APPLICATION FOR VARIATION OF CONDITION TO PLANNING APPLICATION NUMBER 2014/3303/P - GRANTED APPROVAL FOLLOWING APPEAL ON 14.11.2014

LOCATION 50 Aberdare Gardens Hampstead NW6 3QA	CLIENT Marta Ienco	DRAWN BY GN	DRAWING TITLE Second Floor and Roof Plans AS PROPOSED	JOB No 2499	SIZE A3	
JOB DESCRIPTION Alterations to existing roof access	SCALE 1:100 @ A3	STATUS Planning	CHECKED BY	DRAWING No 011	REV C

Proposed Roof Plan

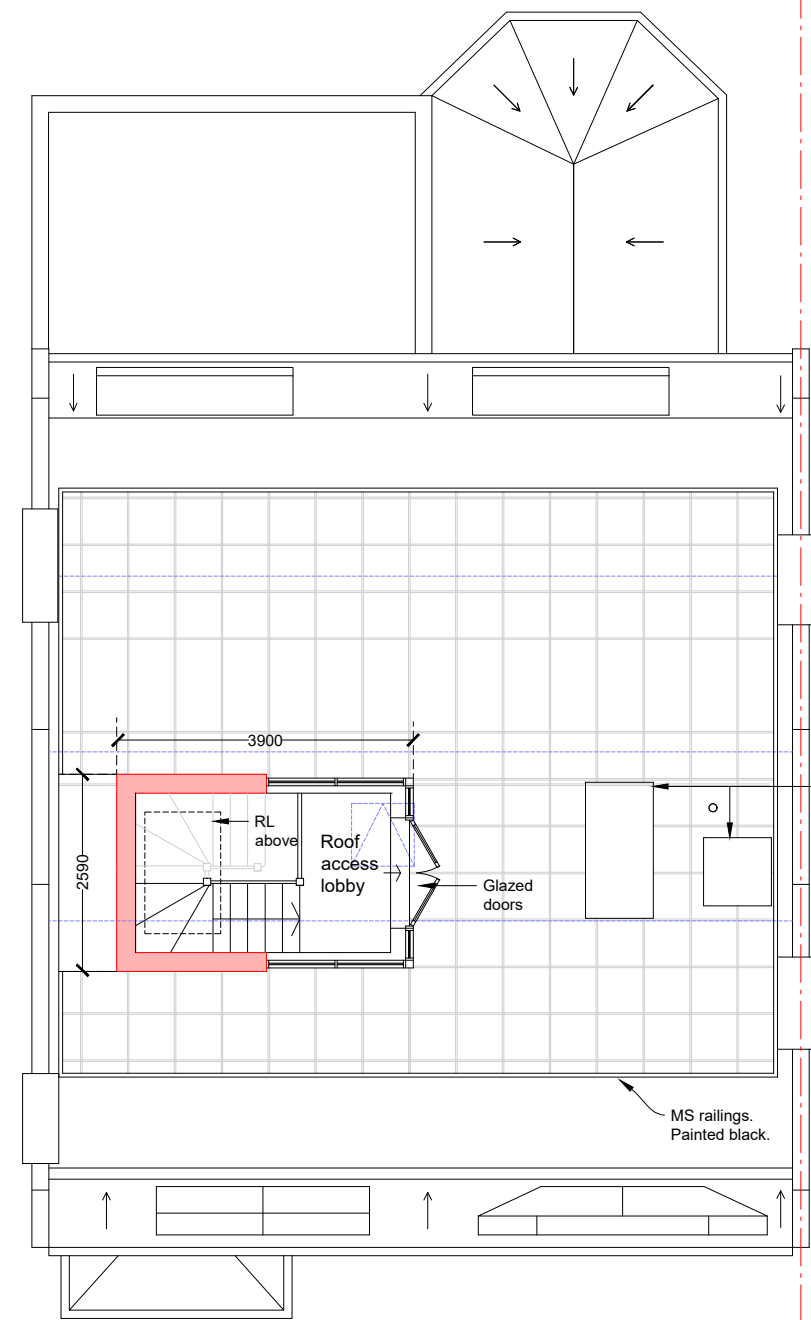
The proposed roof access lobby differs from the approved (under application 2014/3033/P) in that the roof access lobby is higher to allow standing access and longer to allow for an enclosed landing at the top of the stairs. The approved access was in the form of a sliding glazed box which needed to be retracted to allow access to the roof.
